Sacramento Convention Center Renovation and Expansion and 15th/K Street Hotel Projects

Final Environmental Impact Report | June 2018

TABLE OF CONTENTS

Figure 2-12
Pedestrian and Bicycle Plan

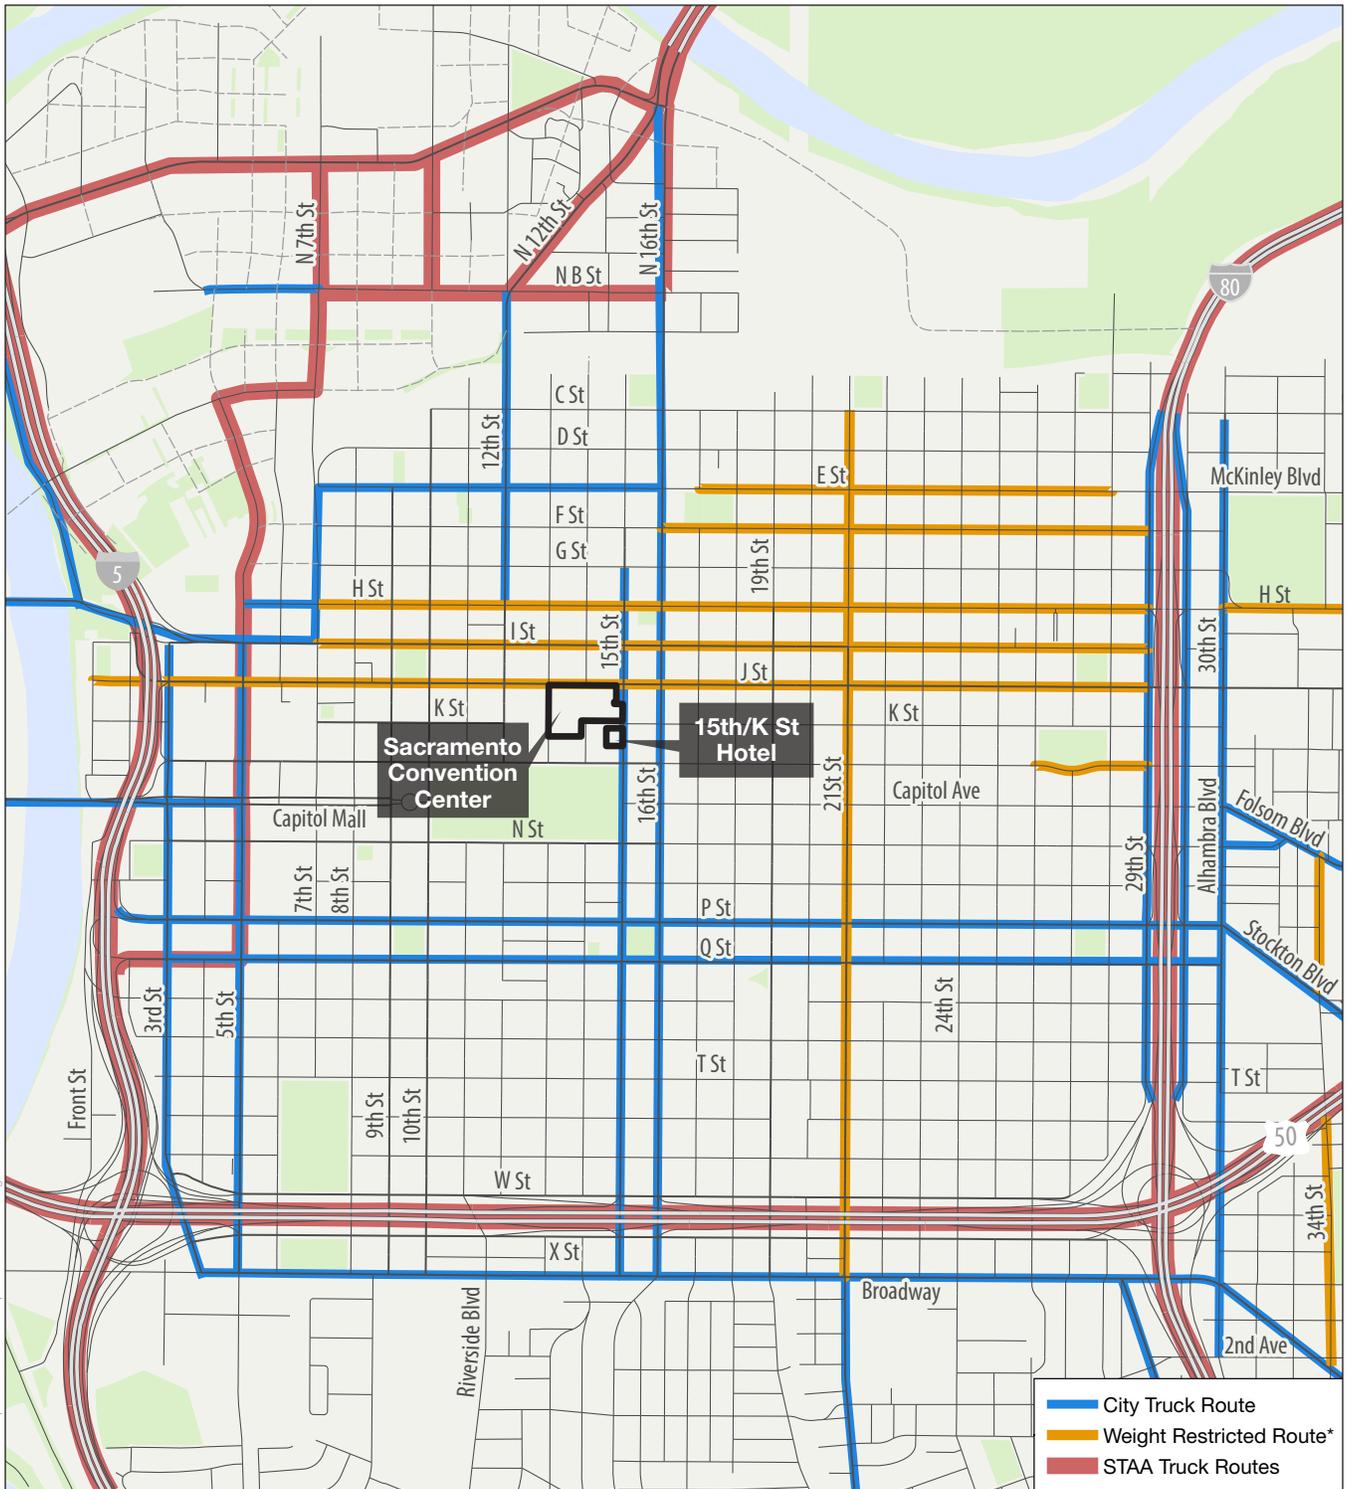
Figure 2-12, Pedestrian Circulation Concept Design, is retitled to “Pedestrian and Bicycle Plan”, and is revised to show the updated SCC design and include the Bicycle Plan.

Figure 4.1-1
Photo Location Map

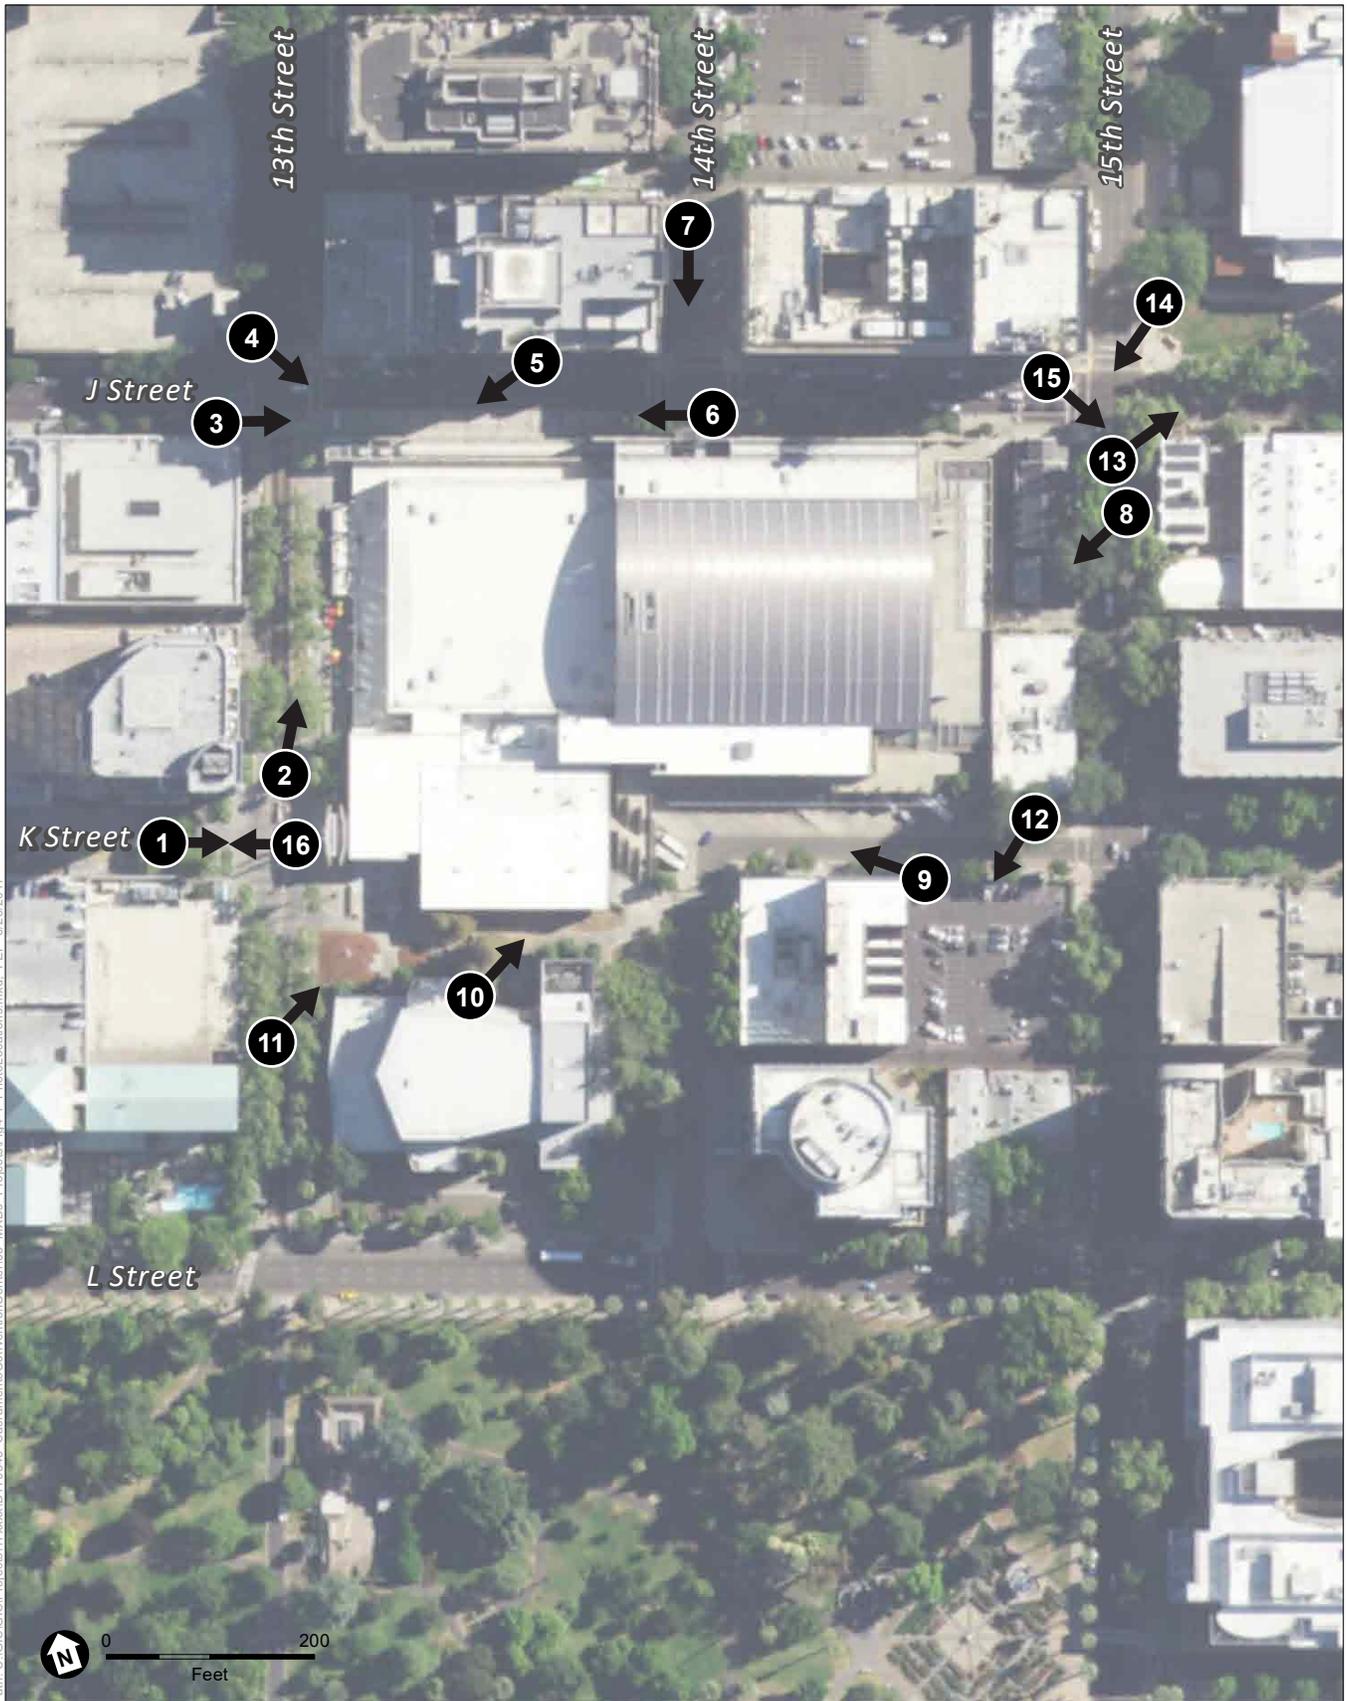
Figure 4.1-1, Photo Location Map, is revised to show the correct street names for 13th Street and 14th Street.

We are reading the EIR with great interest. One observation, the map in section 4 marked “Figure 4.1 – 1” Photo Map Location is incorrectly marked. 13th and 14th Street locations should be swapped. A quick question, the report is lengthy, can you reference the best section/pages in which to find impacts during construction and afterwards, on the adjacent properties. We zeroed in on Section 4, but couldn’t find the info we were looking for.

- O1-1 The comment identifies incorrect street labeling in Figure 4.1-1. Figure 4.1-1, Photo Location Map, is revised to include the correct street names.
